**Comments regarding**  
**Phased Final Map PID 9965**  
**3333 California Tentative subdivision map**

Map by: BKF Engineers

Dated: 6/12/2019

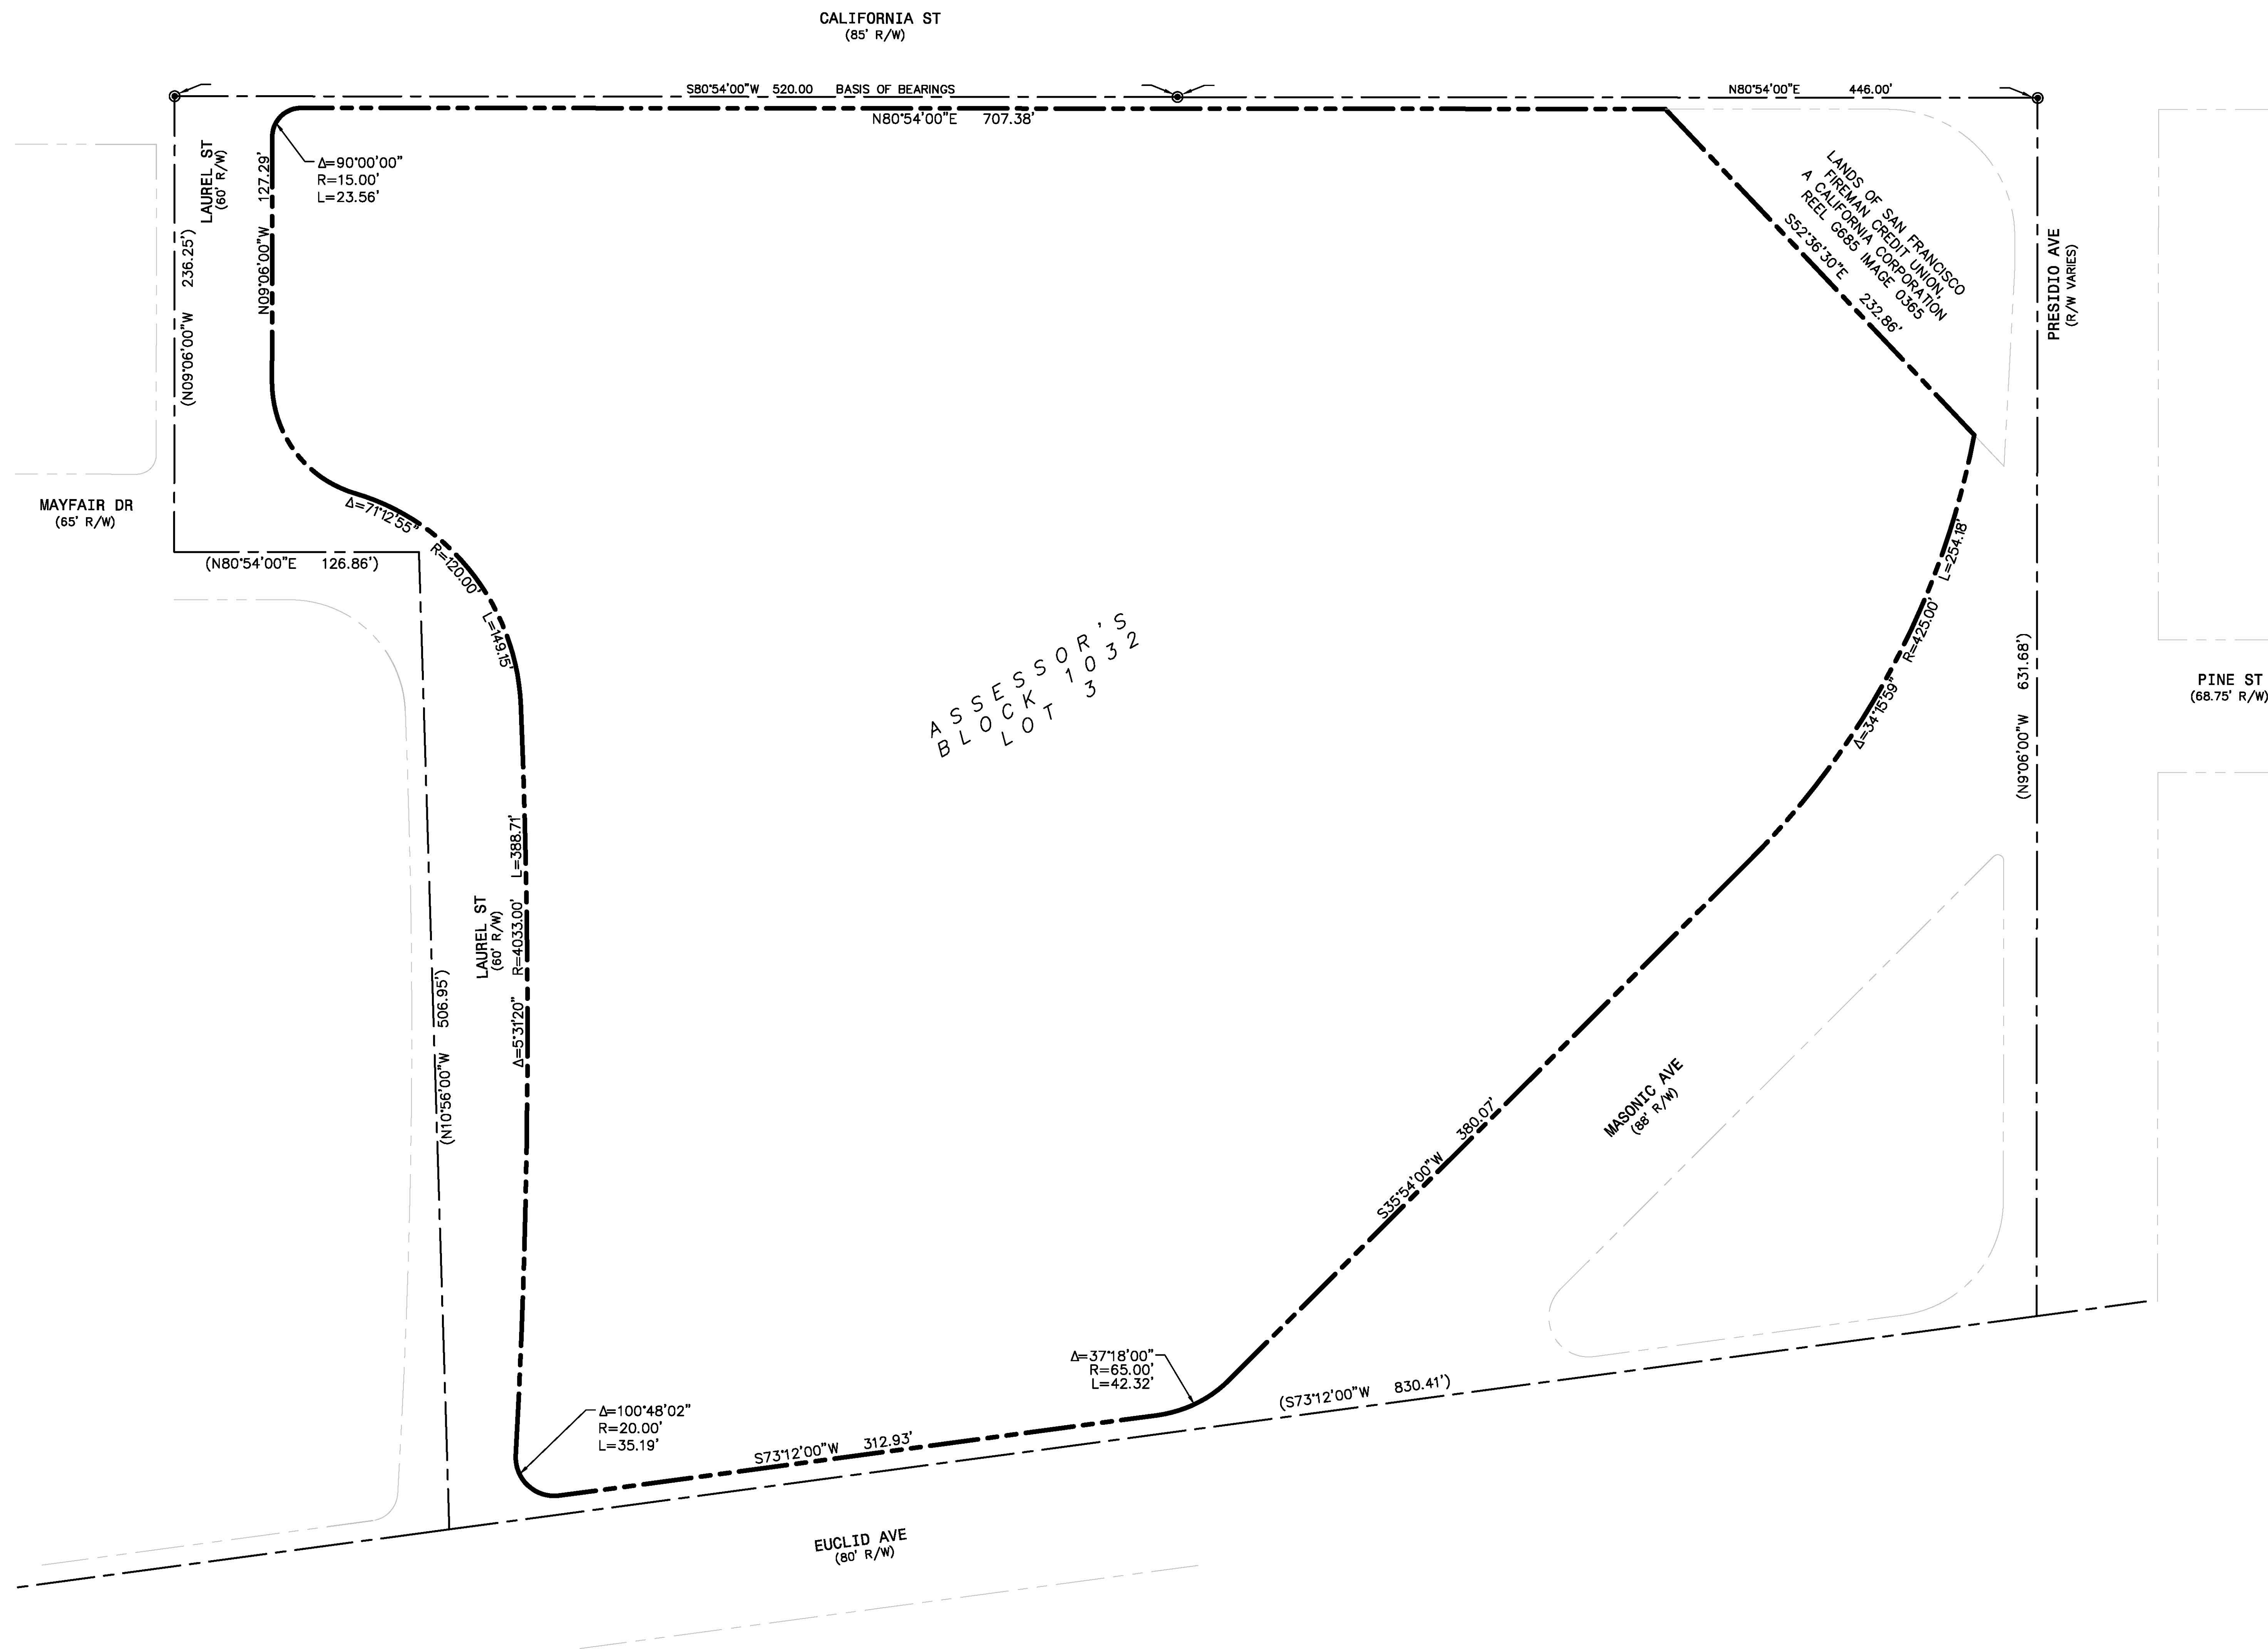
- Label Monuments with description and MID (Monument Identification – available from CCSF)
- What is the origin of the legal description?

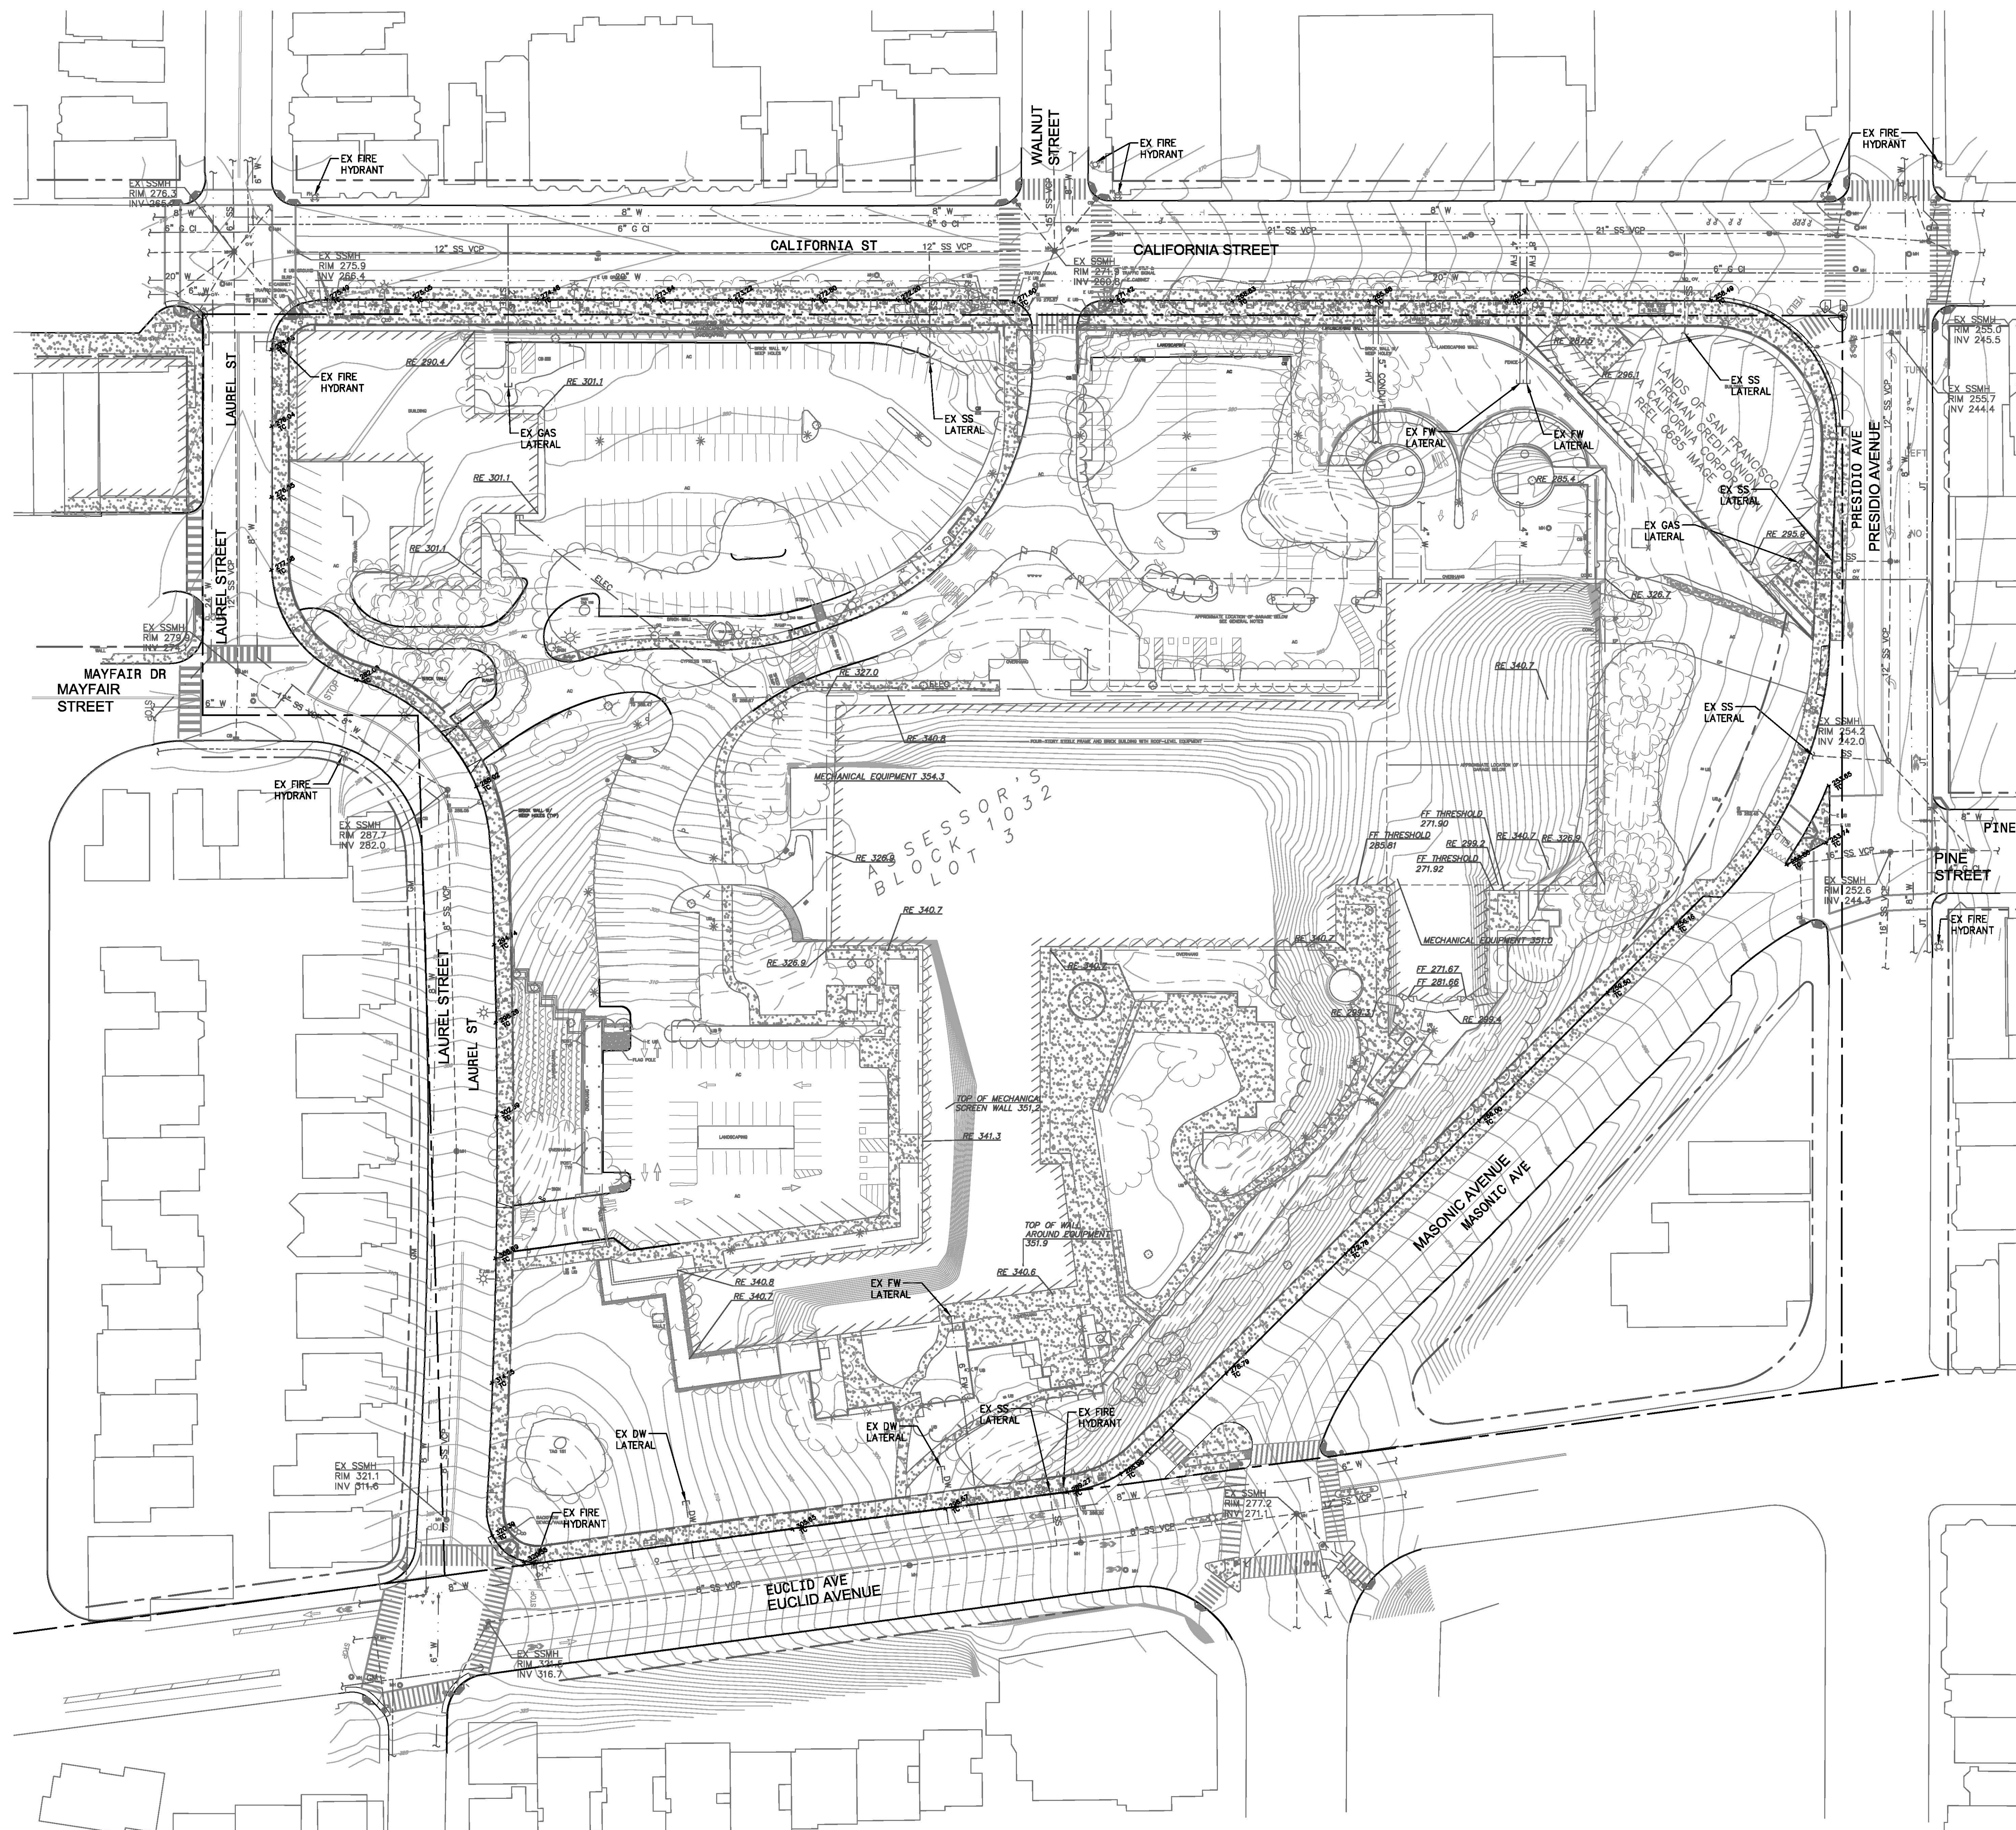
- Provide location of adjacent Fireman Credit Union building. Show distances from this building to the PIQ.
- All Streets are double labeled (no correction necessary to this map).
- Map shows contours under existing buildings, unclear as to lower building levels and ground join.

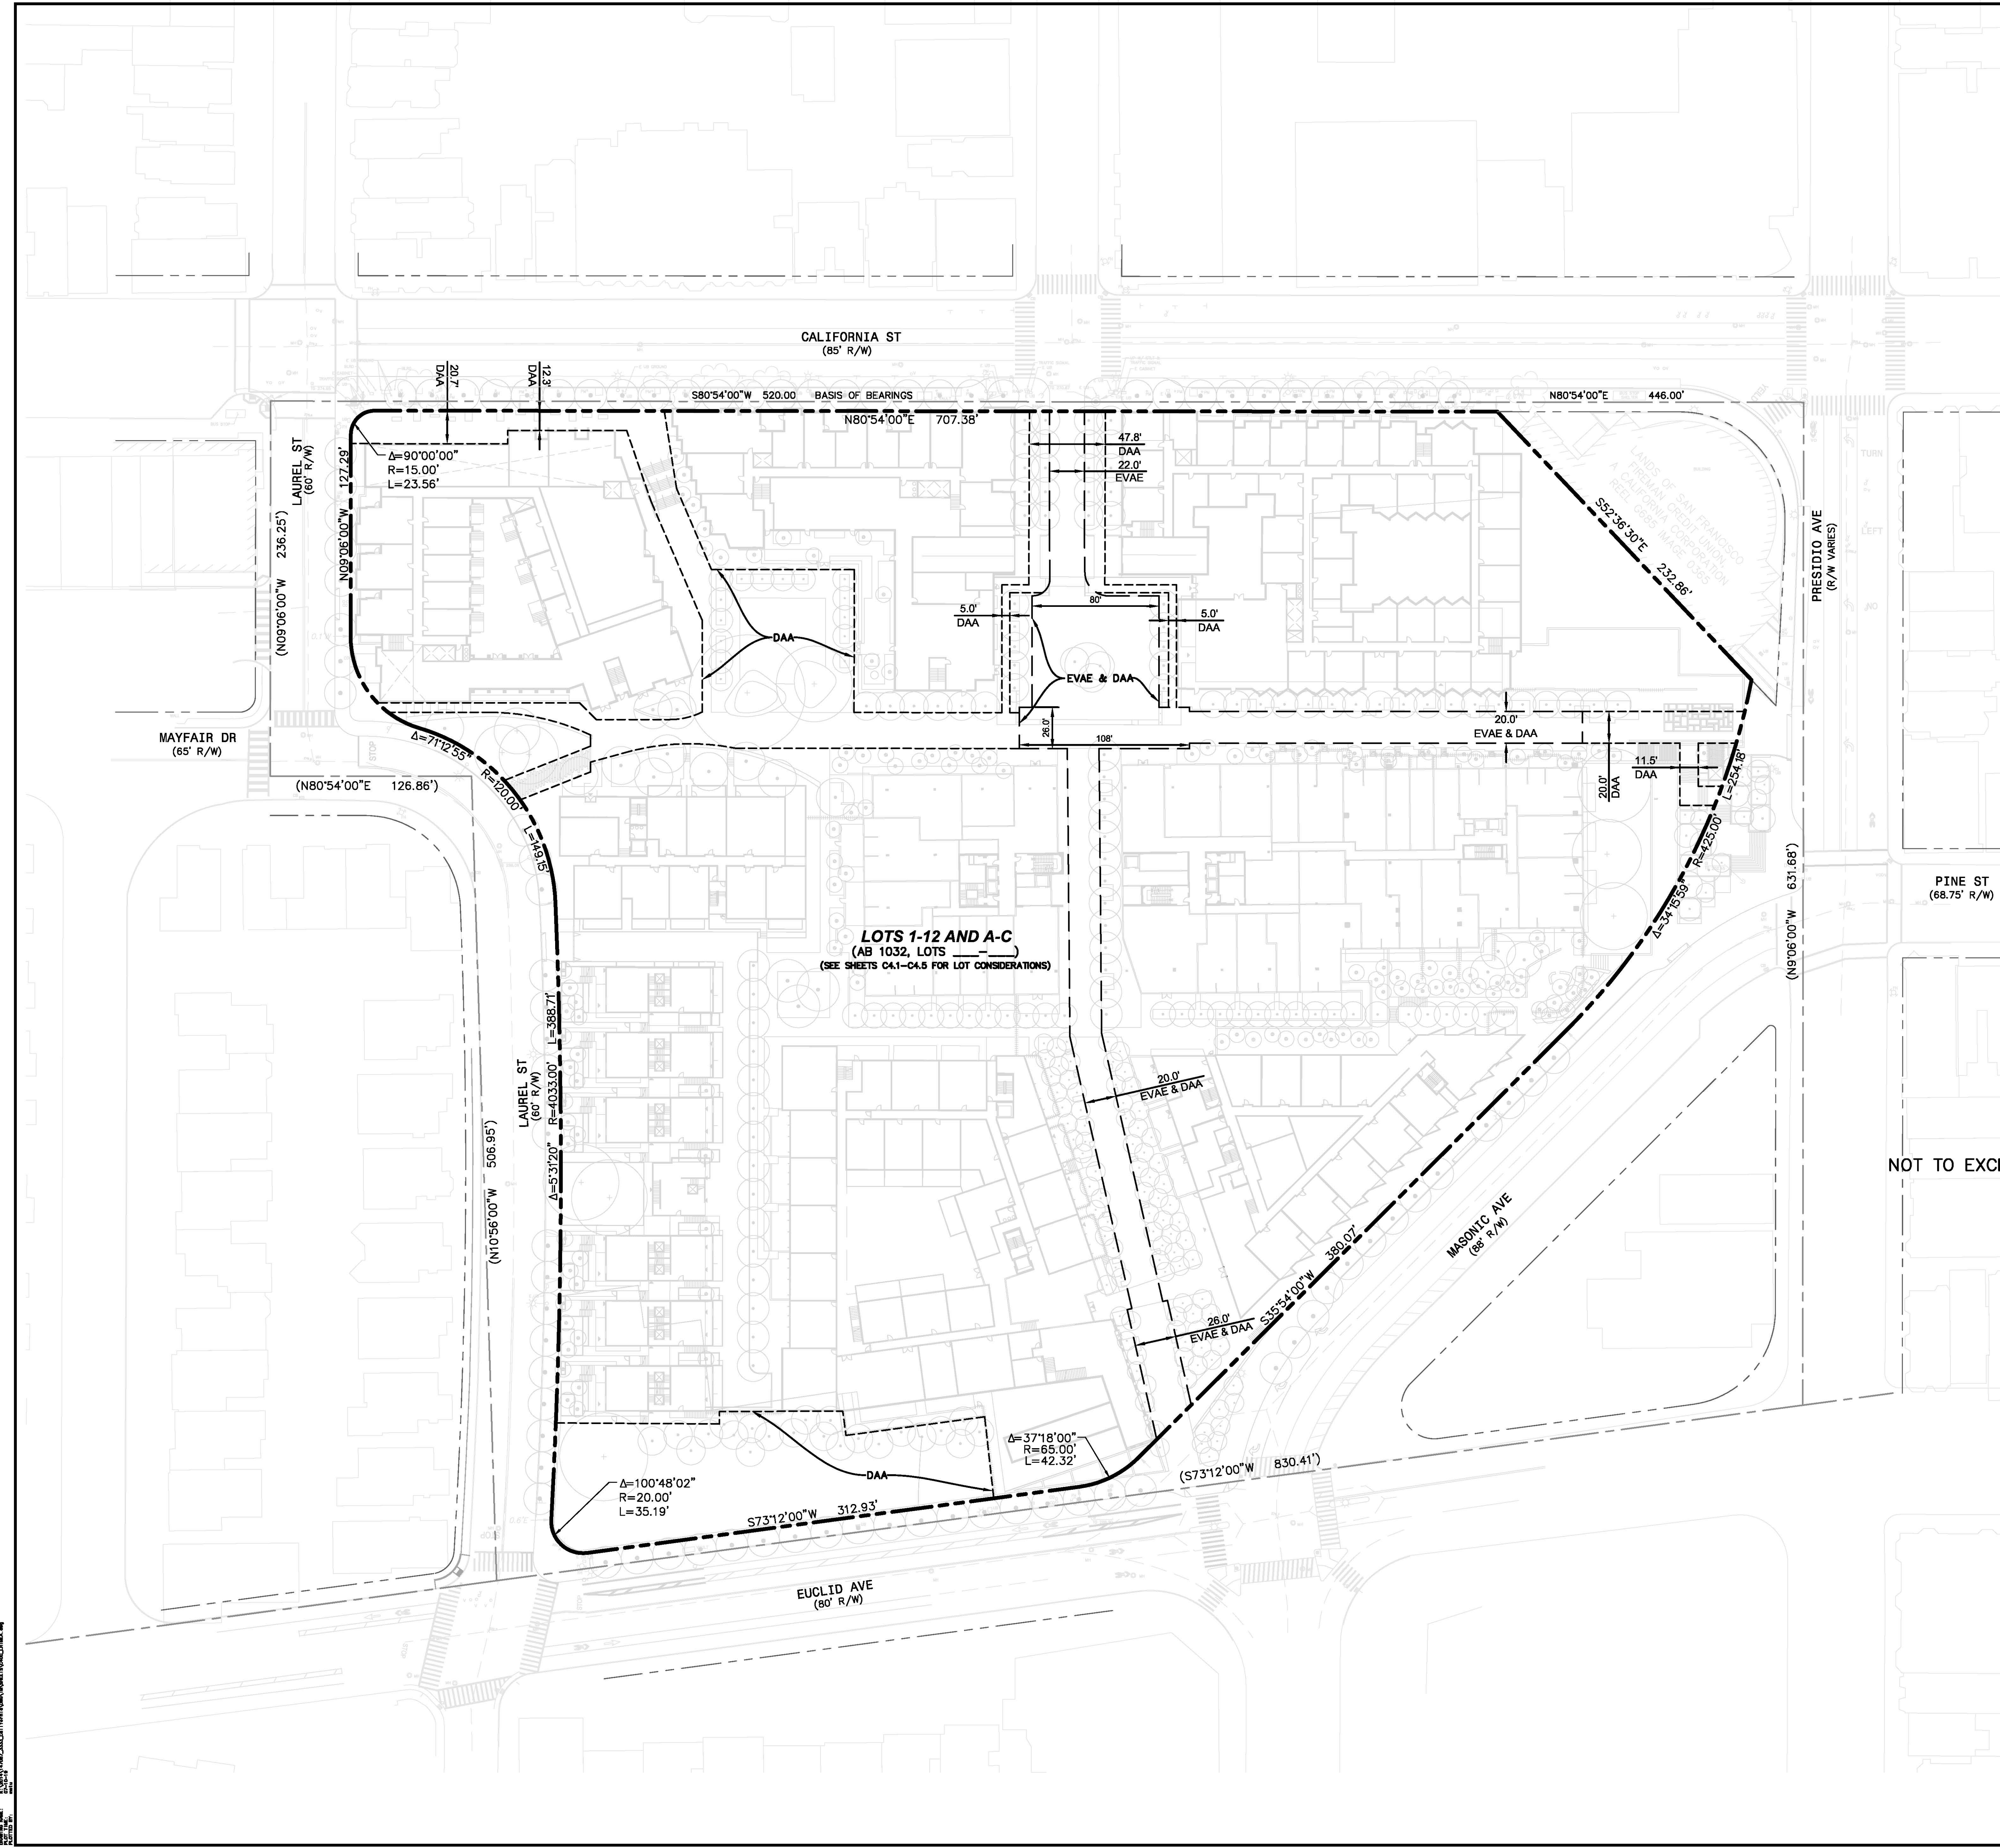
- “Lots 1-12 and A-C” is confusing. If this is representing all lots, then show horizontal boundaries.
- D.A.A reference should probably be referred to as R.E.A. (reciprocal easement agreement) area.
- If this page is only to delineate the EVAE and REA, then please state.
- Will E.V.A.E. require separate agreement(s) and documentation? I believe so.
